Fernald Center Wetlands Restoration and Stream Daylighting

ADDENDUM NO. 4

November 3, 2021

REVISED ATTACHMENT A

STONE WEIR
DETAIL 3
NOT TO SCALE D-2

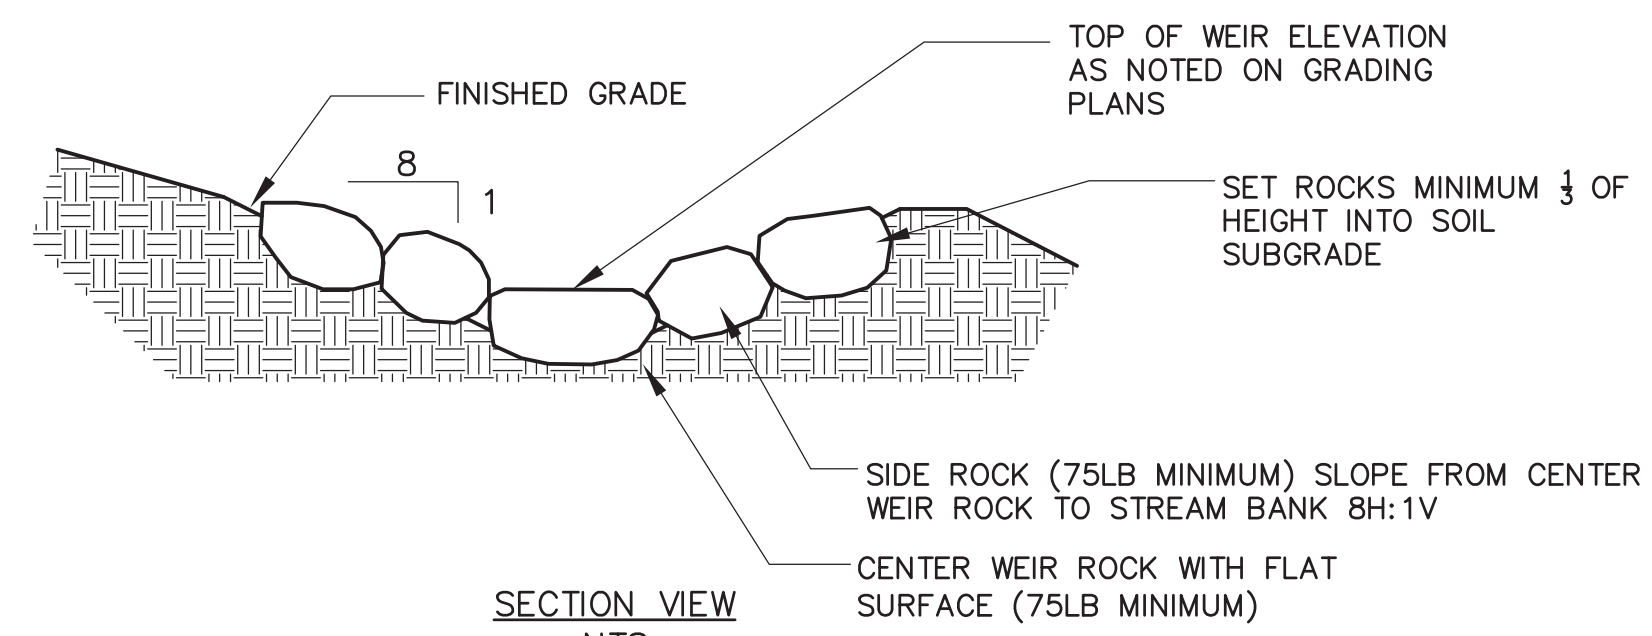
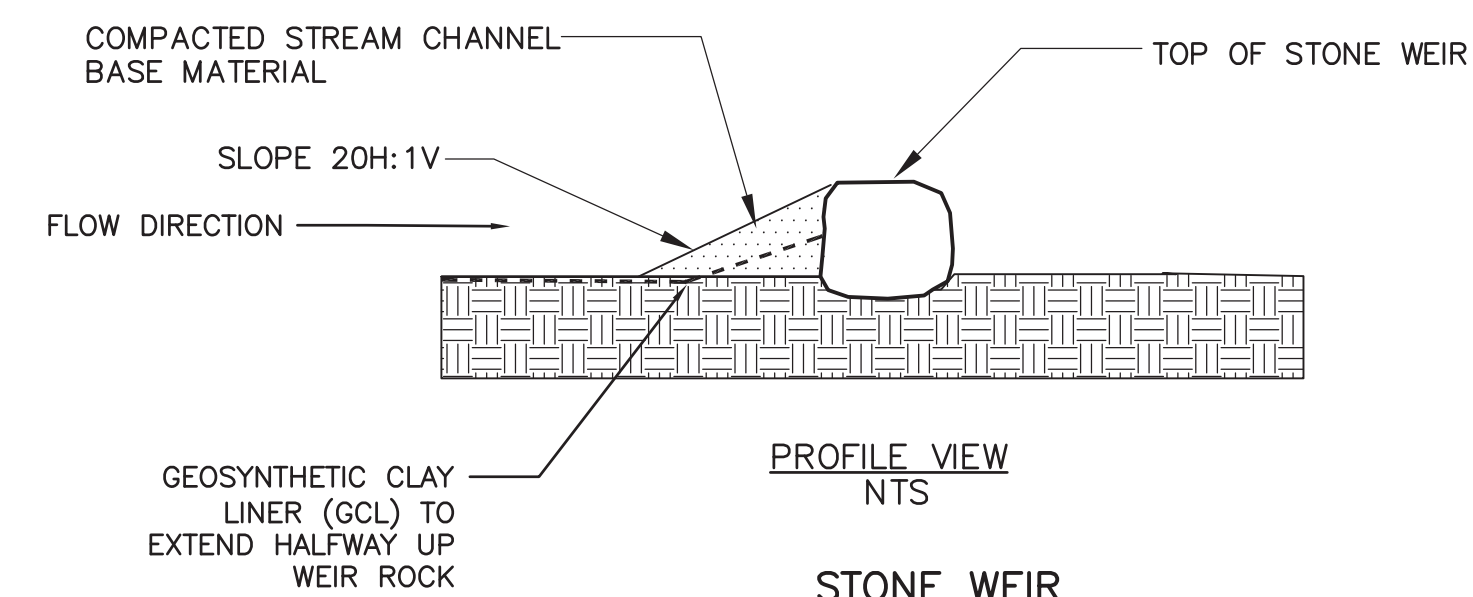
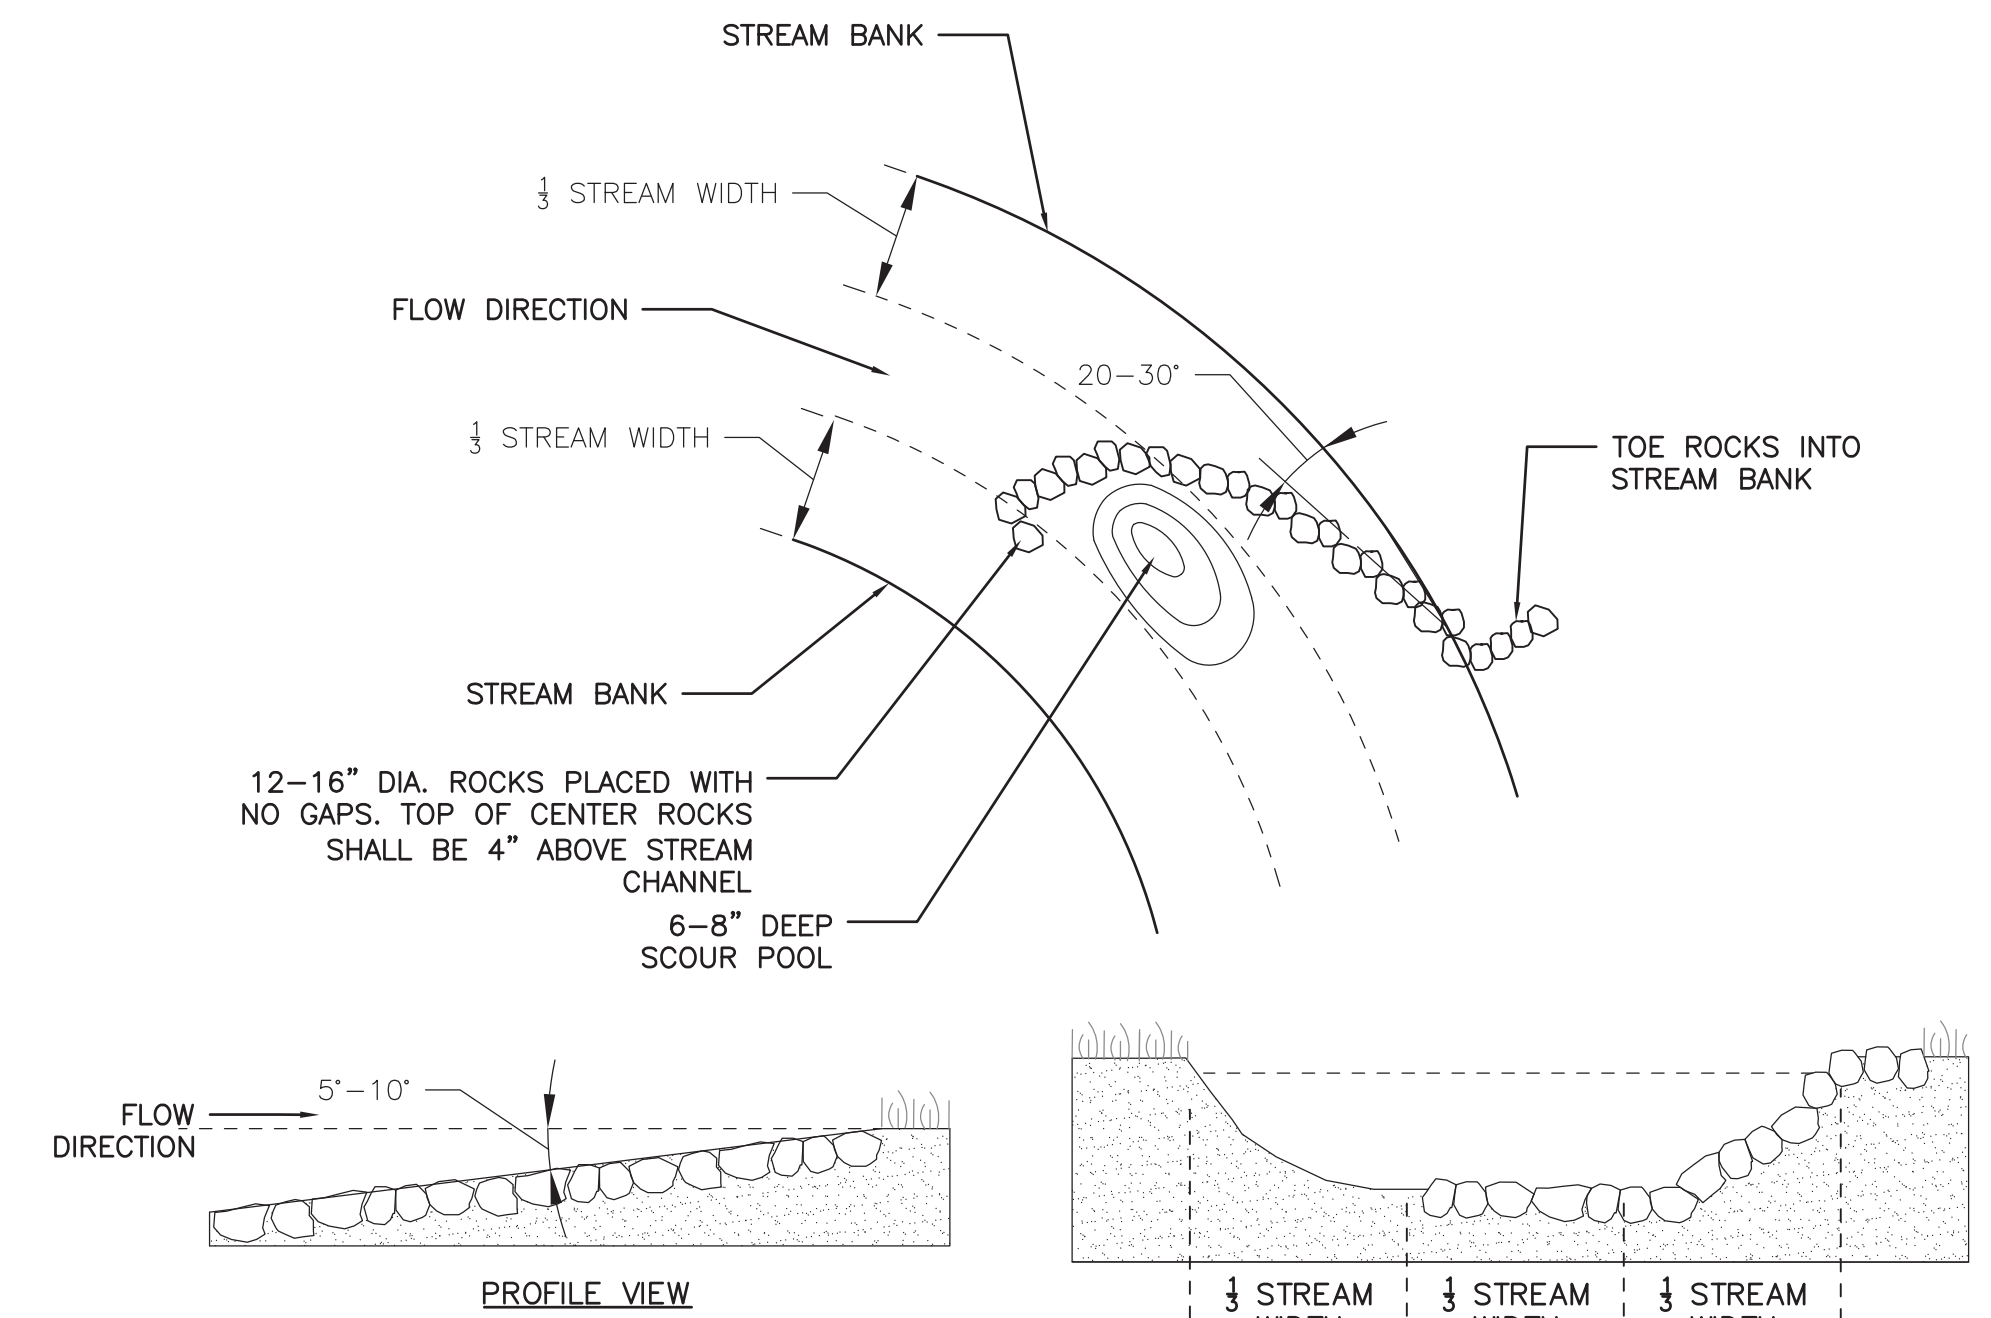
Q16. Drawing D-2, Detail 6 shows a Geosynthetic Clay Liner (GCL) across the proposed stream bed and being cut at weir rocks per Detail 3 and spillway rocks per Drawing D-3, Detail 2. There is no specification provided for this GCL material. Is GCL actually required, because this material would not be placed as shown. The GCL could not be cut or placed around rocks that are placed in the stream. In addition, the GCL would probably need a significant depth of cover material (i.e. stream bed material on top of the GCL) and anchor trenches along each stream bank. Can you please provide more detail about the possible use of GCL.

A16. Geosynthetic Clay Liner (GCL) and all work associated with this item will be removed from the Contract.

DETAIL 6
NOT TO SCALE D-2

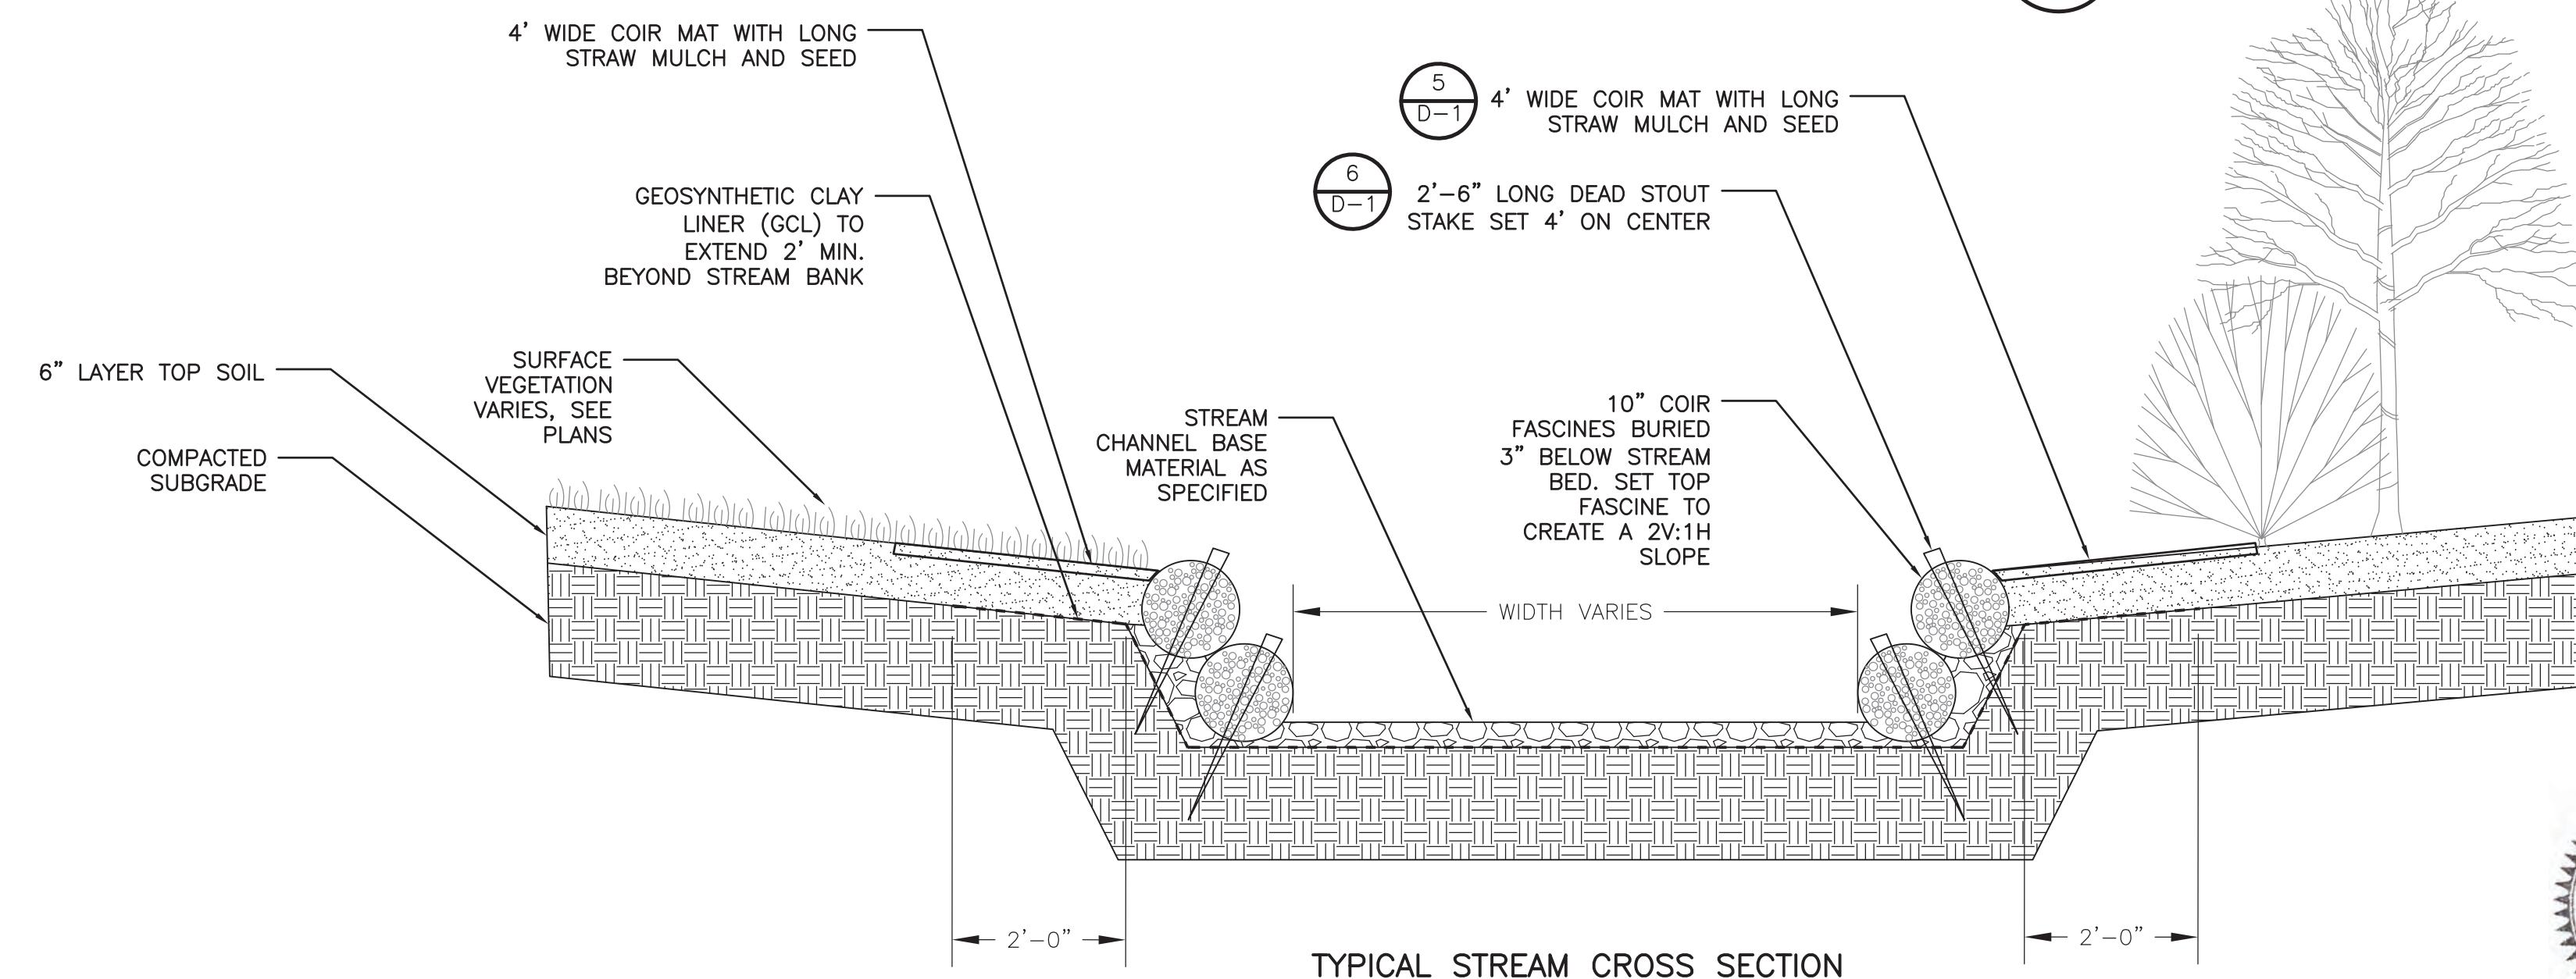
Q17. Per Drawing D-2, Detail 6 can you please provide a material specification and design depth for the “Stream Channel Base Material”.

A17. Upon removal of soil within the constructed stream channel the top soil will be placed back on the constructed banks and stream bed. If supplemental soil may be required it should consist of unscreened invasive free loam or organic compost that consist primary of leaf compost. The minimum depth of supplemental soil shall be 4 inches or as directed by the Engineer.

A3. 10” Coir Fascines and 4’ wide Coir Mat is required along the entire length of the new daylighted stream as shown on the details 6 D-2 and 5 D-1 on Sheets D-1 and D-2. Live Fascines for the project is as shown on Sheet L1 along the slopes of the proposed pond.

CONCRETE HEADWALL
DETAIL 1
NOT TO SCALE D-3

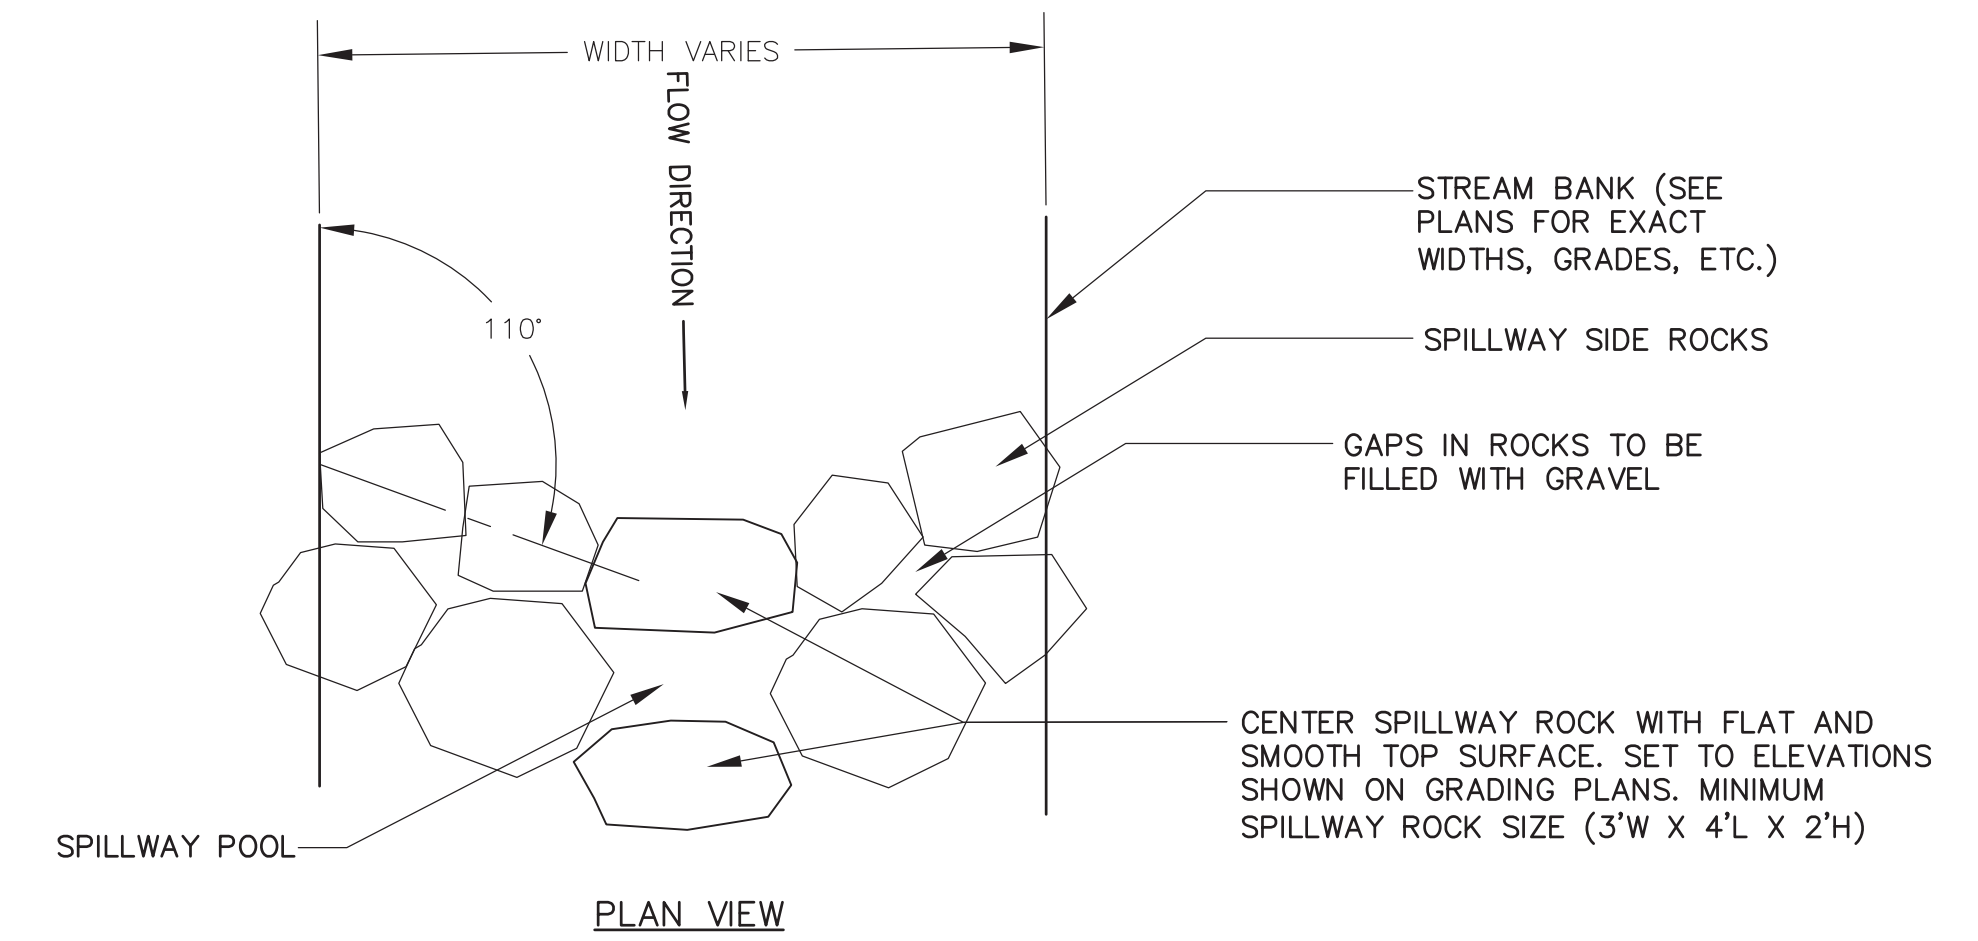
Q4. Answer 7 - The Concrete Headwall shown on Drawing L-3 appears to have dimensions very different than those shown on Drawing D-3, Detail 1. Should the Concrete Headwall be constructed as shown on Drawing D-3, Detail 1 with W1 & W2 dimensions per the 18" RCP that is required?

A4. Drawing D-3 Detail 1 is deleted. Concrete headwall shall be constructed per dimensions as shown on Drawing L-3 and reinforcing details shown on Drawing D-3. Contractor shall include shop drawings of the proposed headwall stamped by a PE for approval by the Engineer during submittal review.
